FILE CSSTP-0006-00(049),
Cobb & Paulding Counties
SR 360 FM SR 176/COBB TO
SR 120/PAULDING
P.I. No. 0006049

SUBJECT **Request for VE Reversal**

RE: **VE Study Reversal**
CSSTP-0006-00(049), Cobb/Paulding Counties
PI No. 0006049
SR 360 From SR 176/New Macland Rd to SR 120/Paulding

PI No. 0006049
SR 360 from SR 120 to SR 176
Paulding and Cobb Counties
Request for VE reversal

ALTERNATIVE NO.
ROW - 3
STA. 60+00
SHEET 27 OF 32

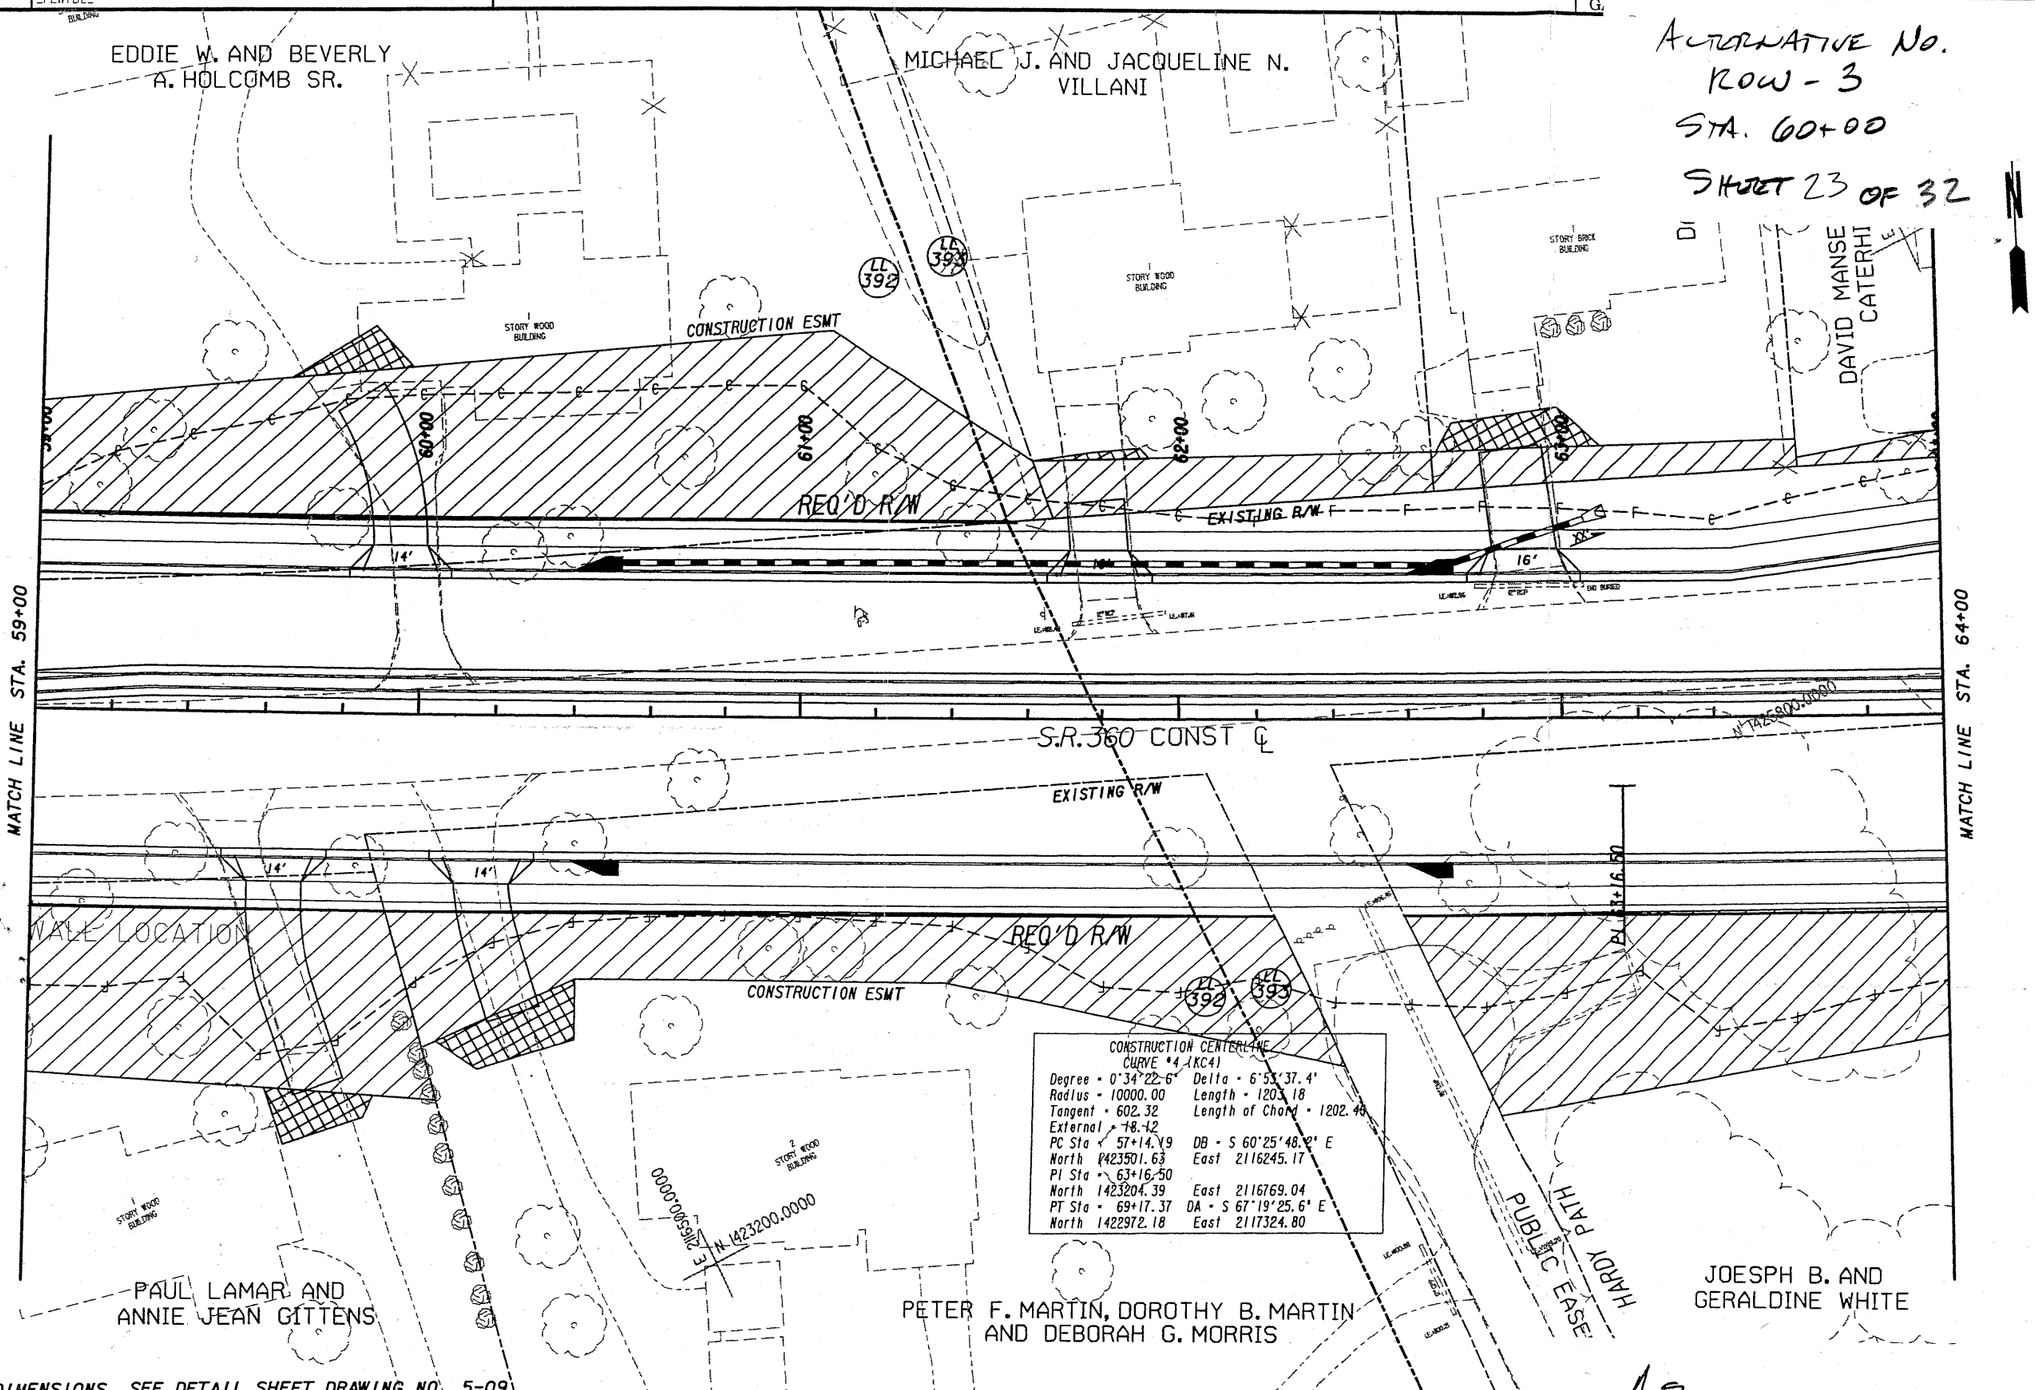
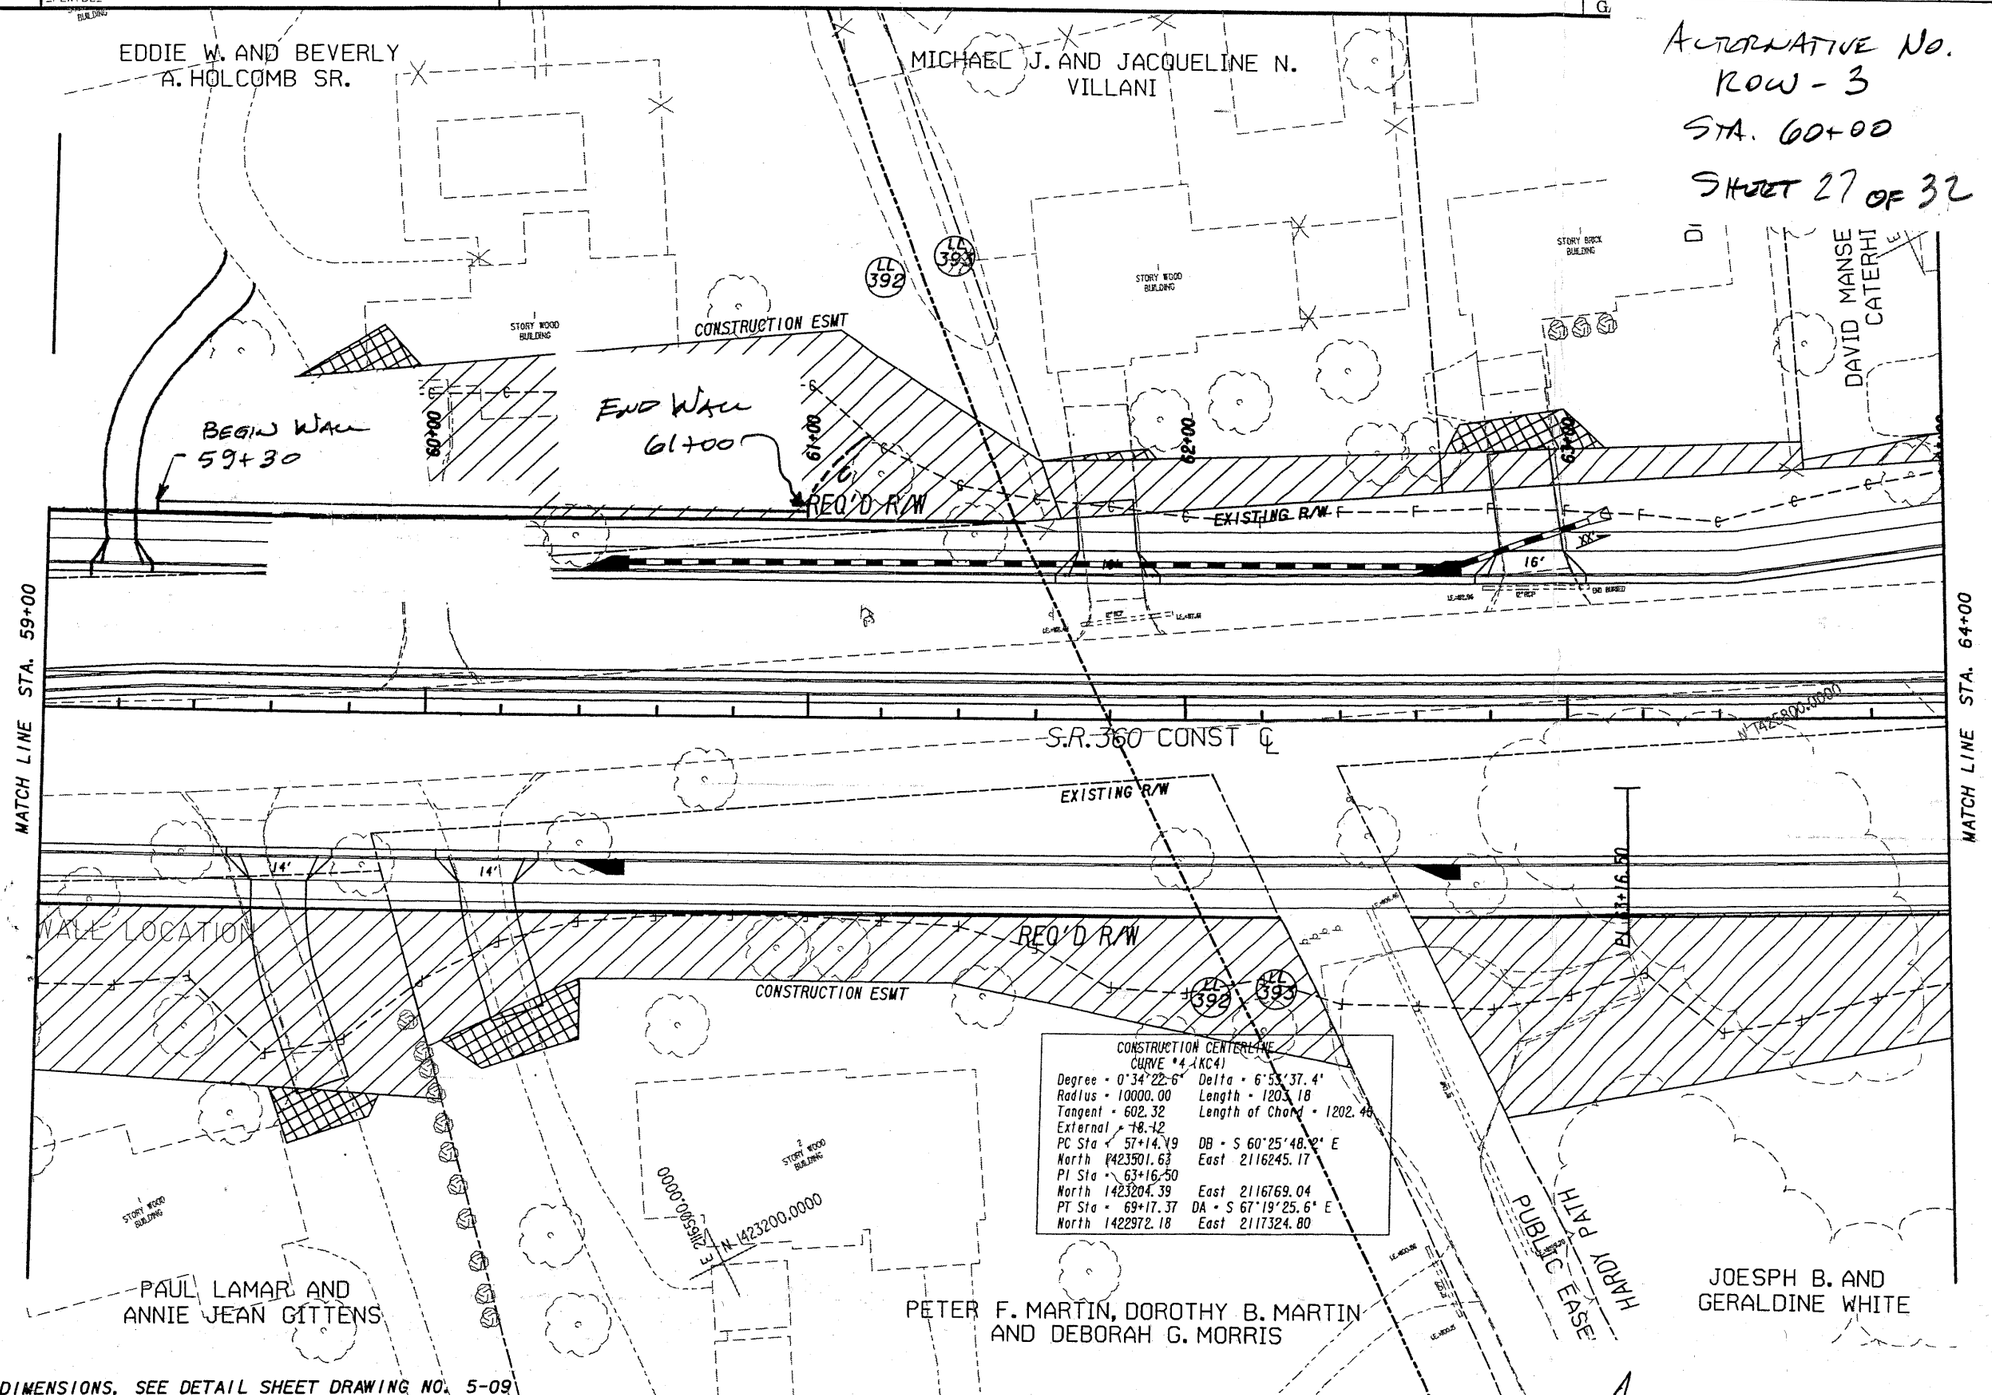
ROW-3	Use retaining walls to reduce right-of-way impacts	$90,179	Yes	This should be done.
